Multistrada V4 Standard MY 2021 (all versions) Multistrada V4 S MY 2021 (all versions) Technical Service Bulletin SRV-TSB-21-004

# CR205 – Multistrada V4 updates – 02/2021 Multistrada V4 Standard MY 2021 (all versions) Multistrada V4 S MY 2021 (all versions) Technical Service Bulletin SRV-TSB-21-004

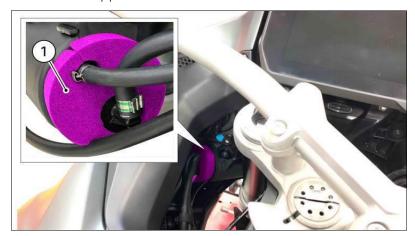
- **3.** Before applying the soundproofing pad, carefully clean the bottom of the canister filter **rubber support (2)** from any impurities. To make this operation easier, turn the handlebar fully to the right.
- 4. Remove protective film (3) on the back of the soundproofing pad.

**5.** Apply the **soundproofing pad (1)** on the bottom of the canister filter **rubber support (2)**, orienting it as shown in the figure.

## Operation 2: Inversion of the side stand return springs

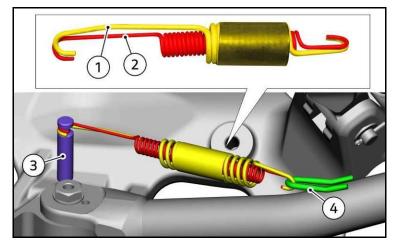
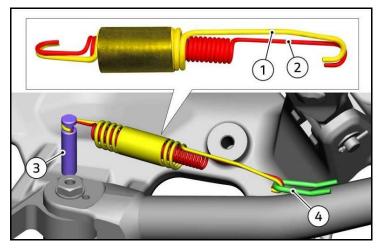
1. Remove the external spring (1) and the internal spring (2) from the fixing pin (3) and hook (4).

2. Reverse the orientation of the external spring (1) and internal spring (2) by fixing them to the pin (3) and hook (4) as shown in the figure, leaving the long end towards the stand.
